**PLANNING AND ZONING COMMISSION
REGULAR MEETING
AGENDA**

Wednesday, February 12, 2020

Manor City Hall – Council Chambers
105 E. Eggleston Street

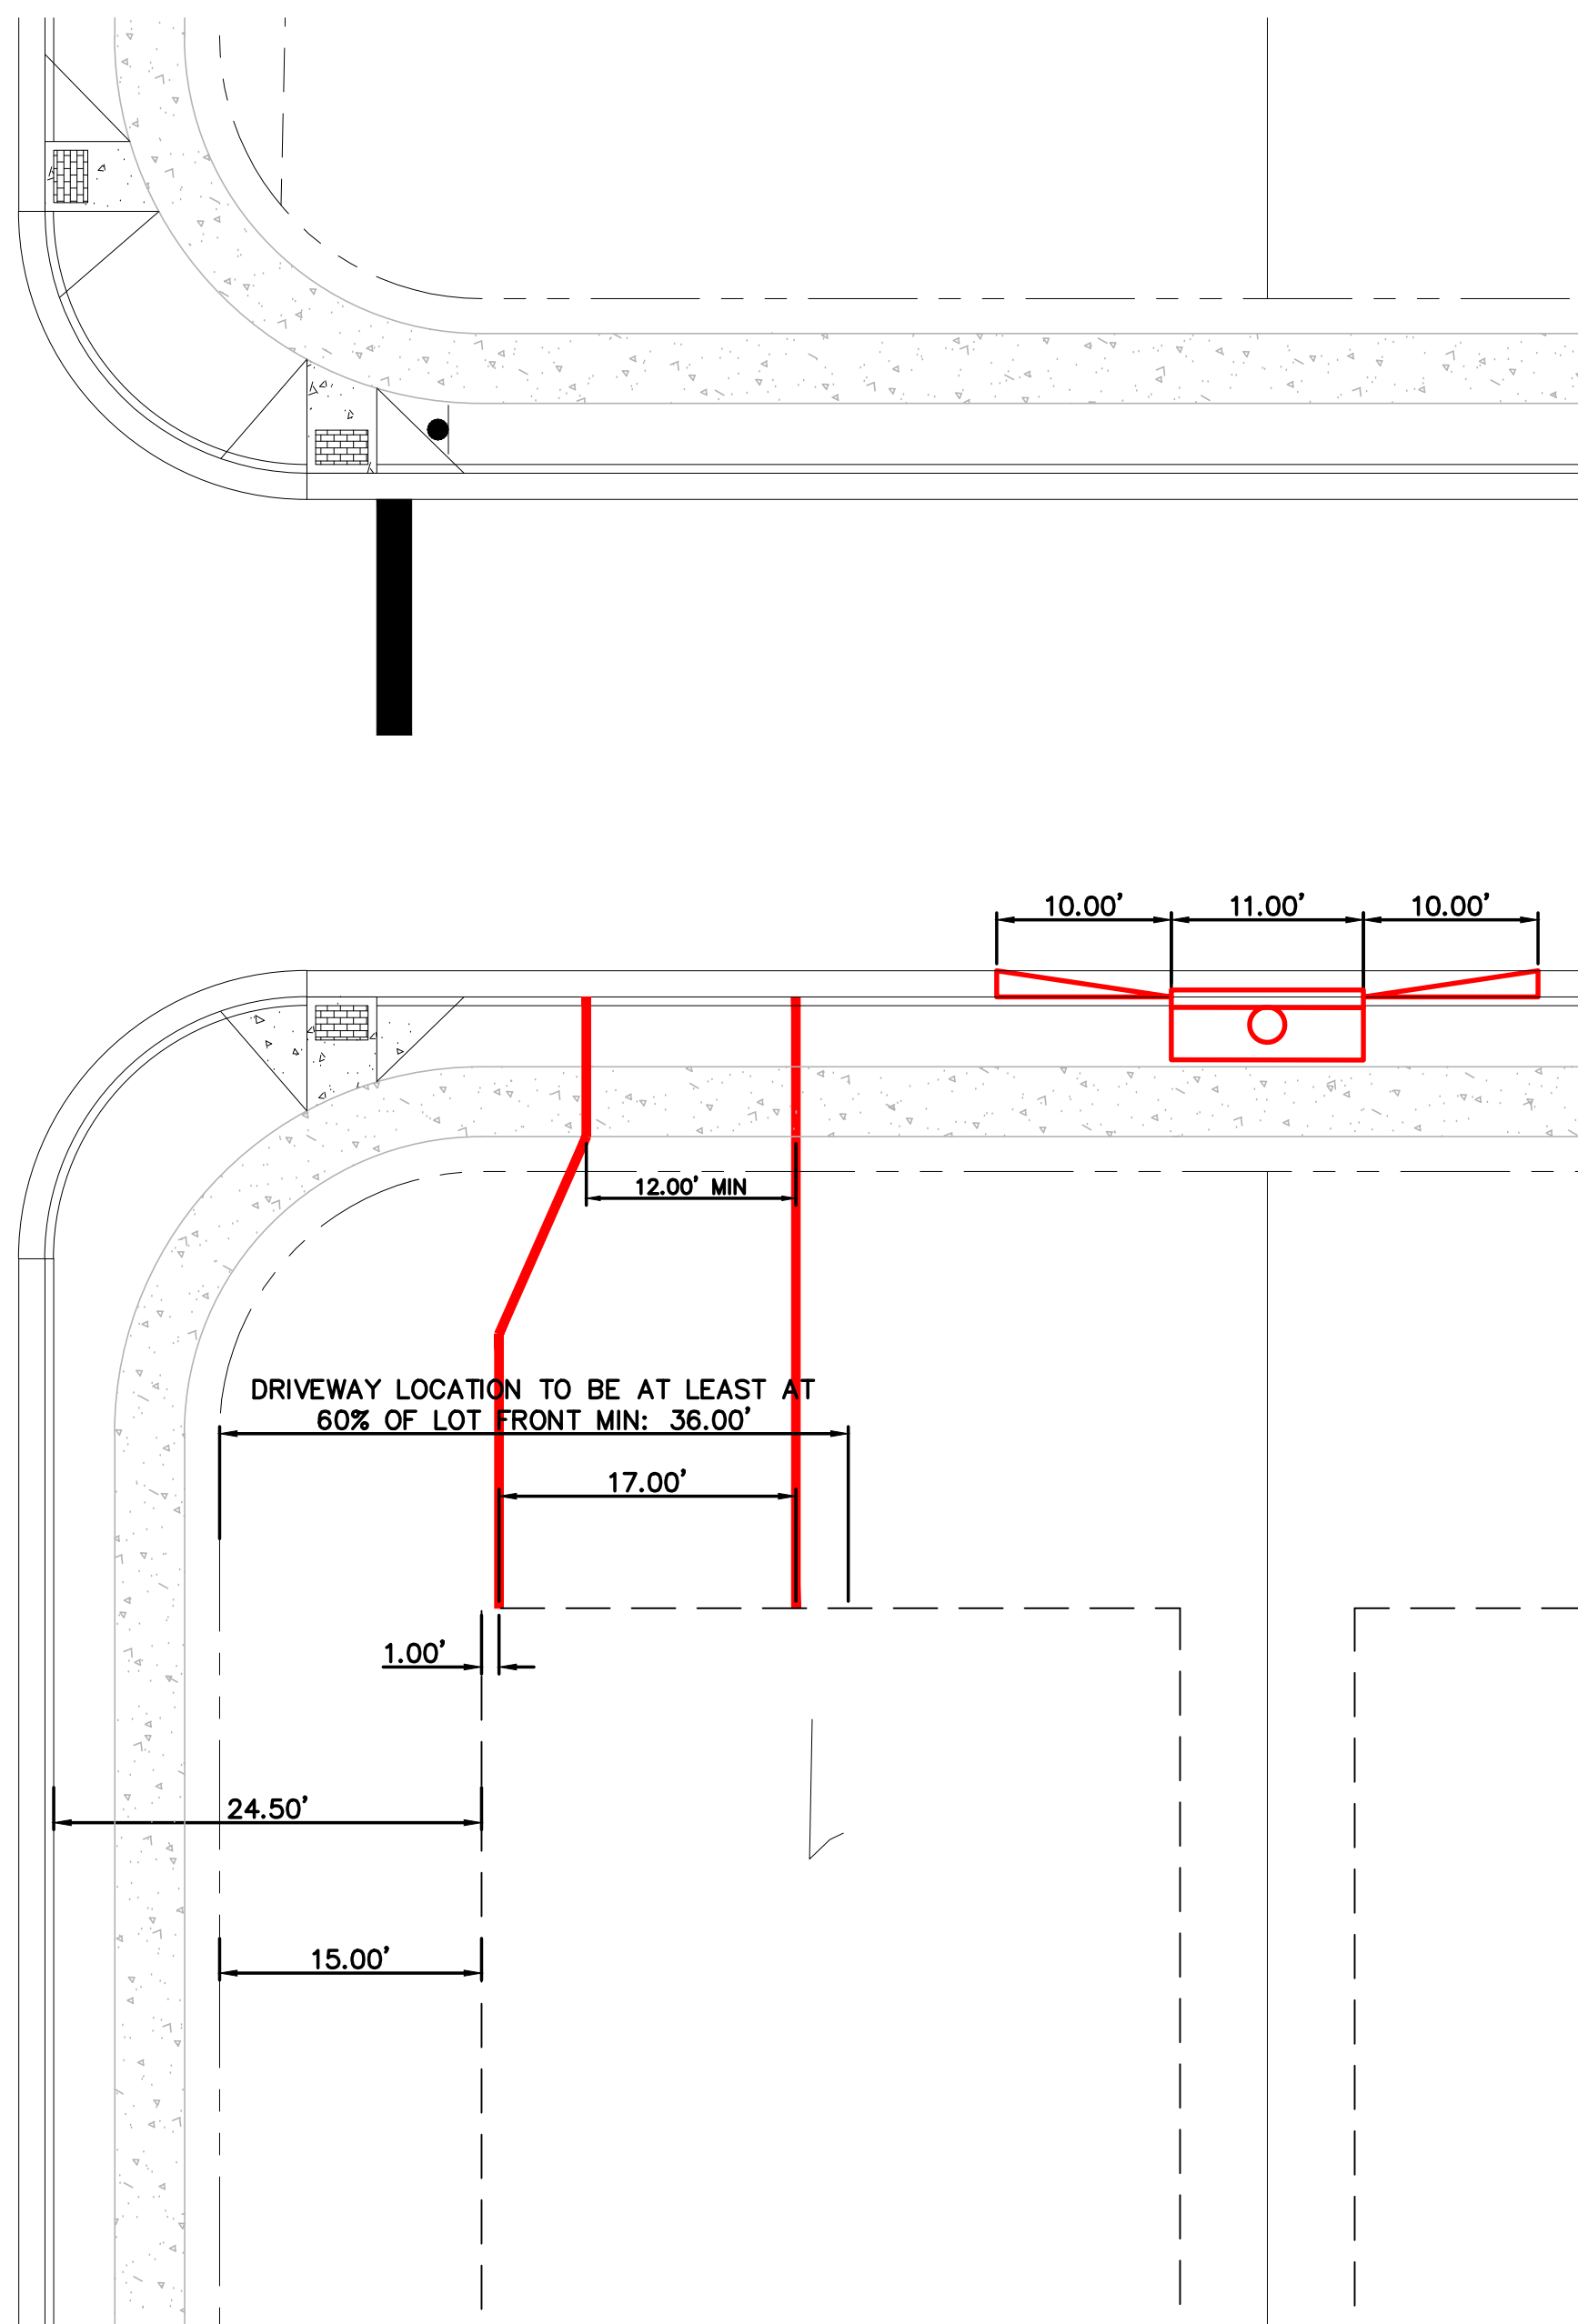
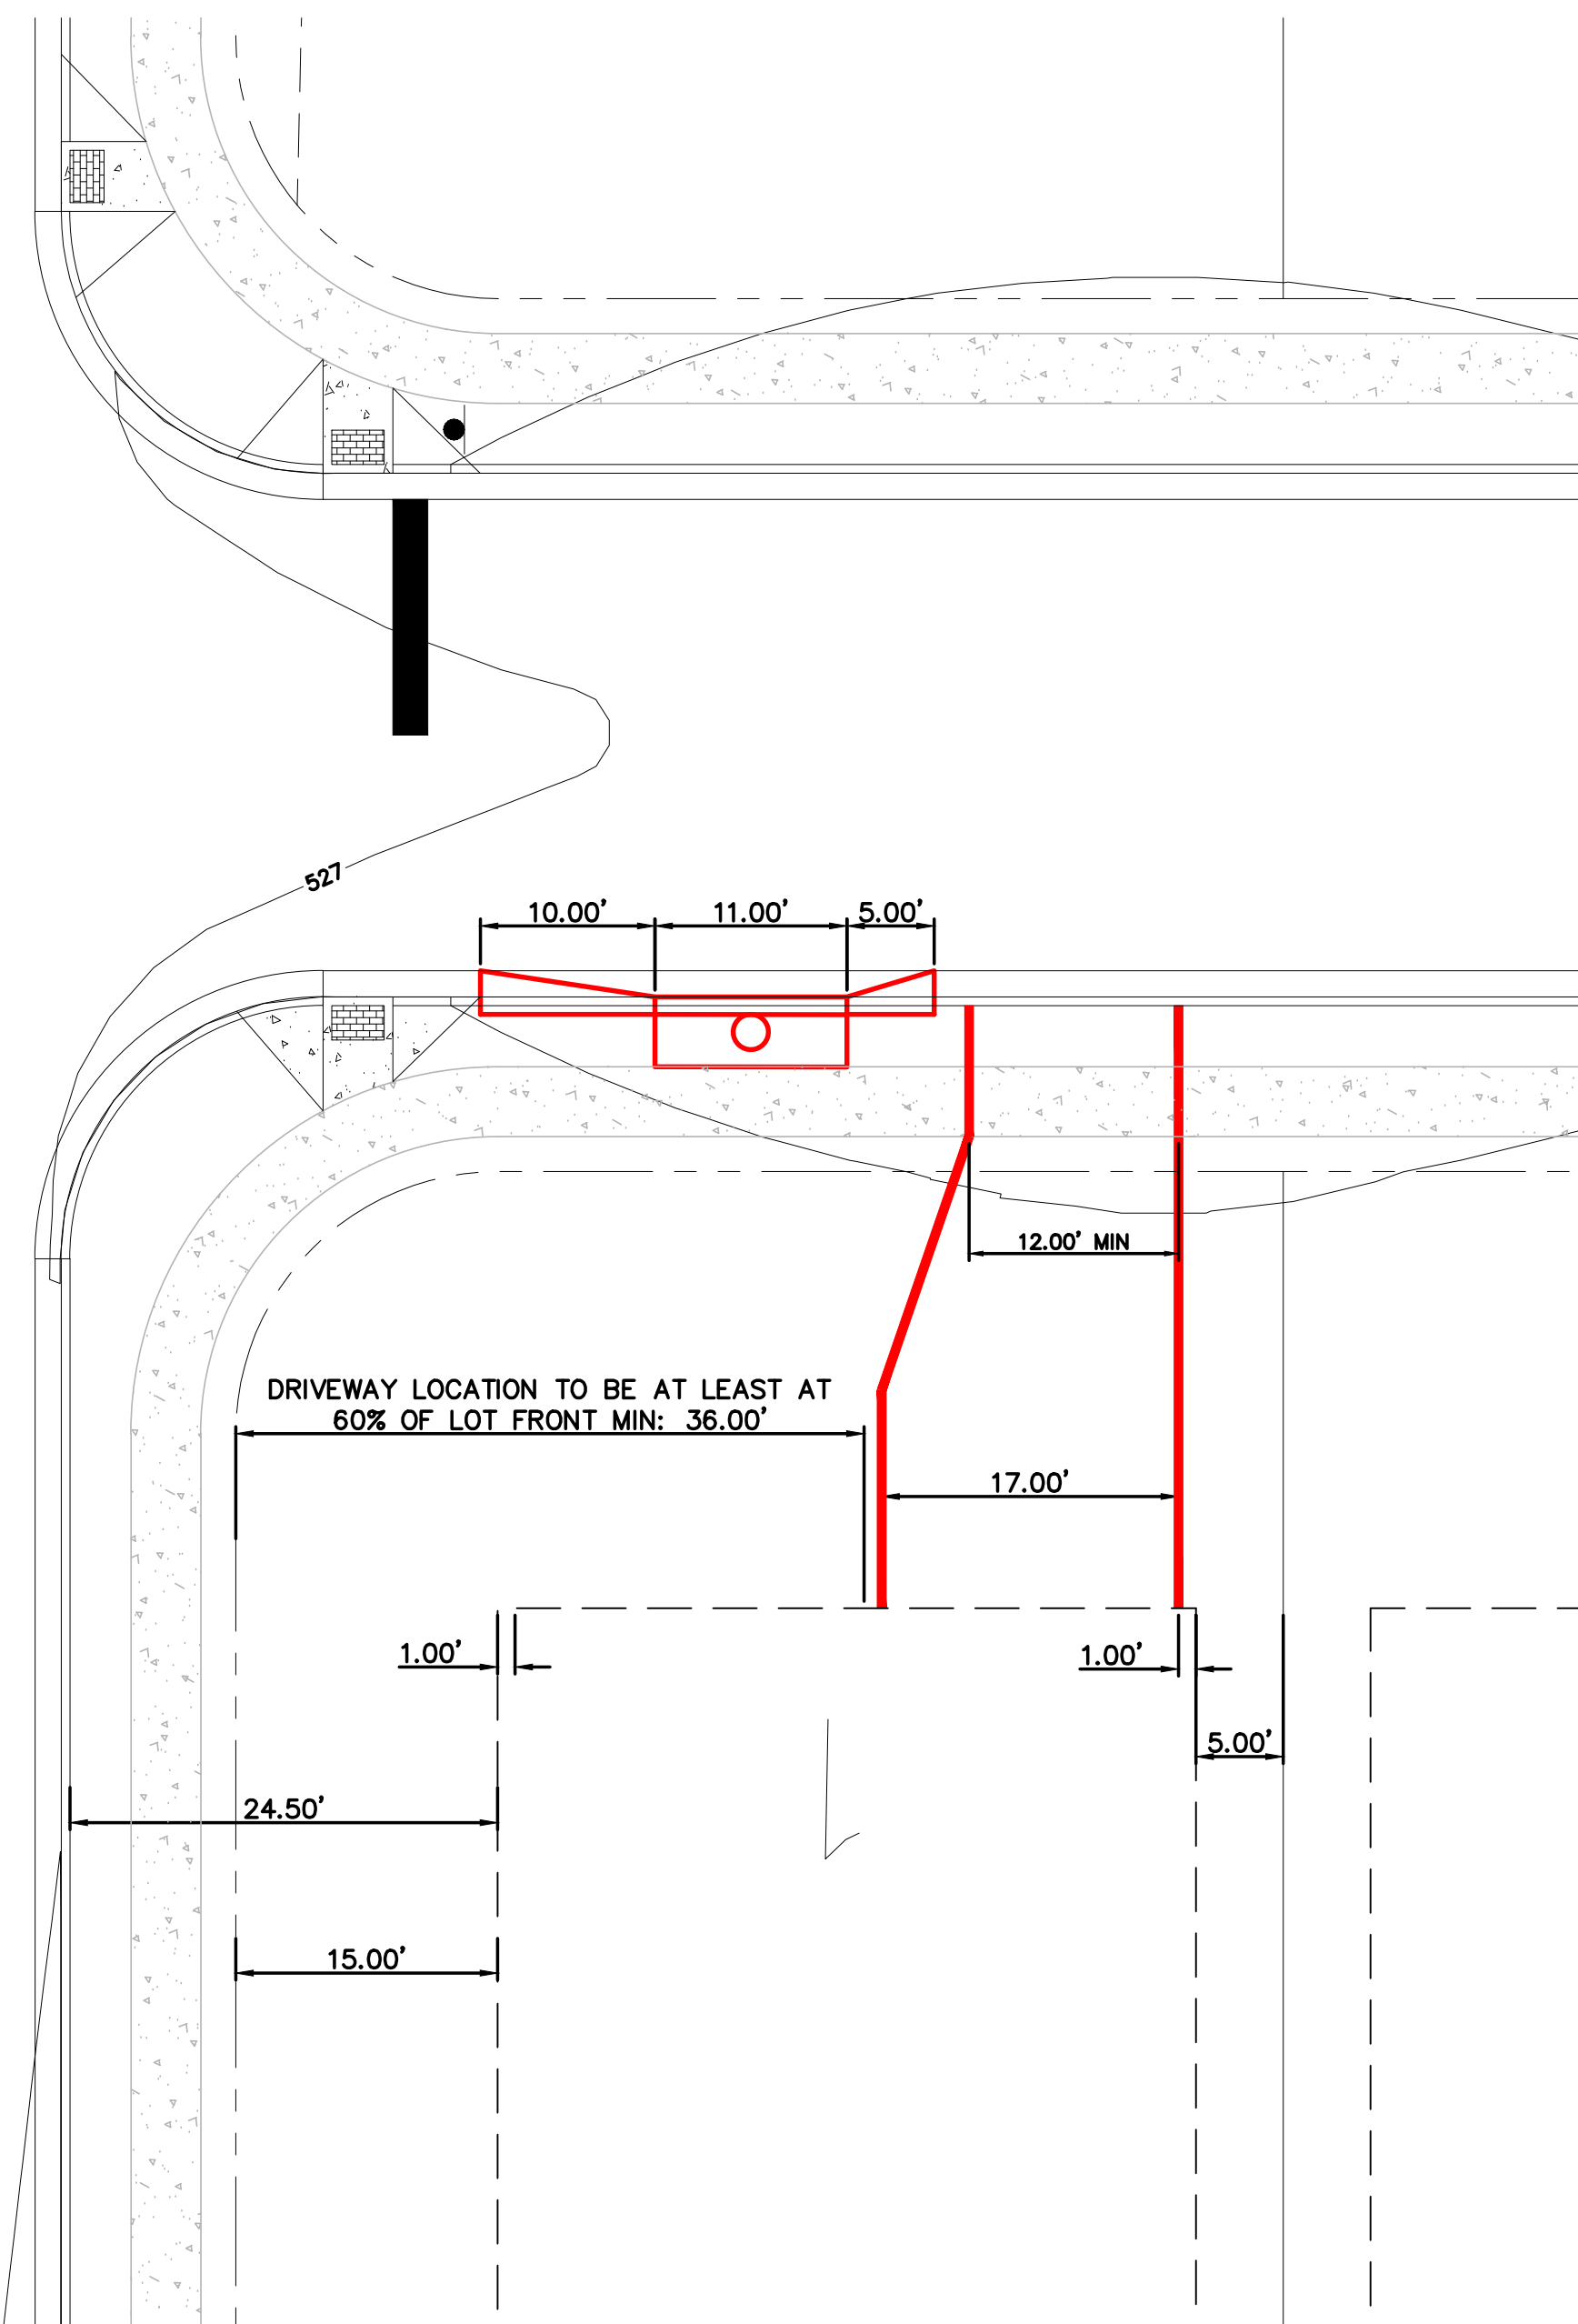
Thank you for the update. The driveways proposed address our concerns. Please make sure you sign and seal these sheets. You should also revise the Section 17 construction plans to note the 5 foot transitions on the appropriate inlets so that there is not an issue when Travis County accepts the streets.

Attached are the exhibits with the 12 ft of minimum width. The "wings" on the driveway apron were taken from the detail of City of Manor and on measurements of the existing driveways.
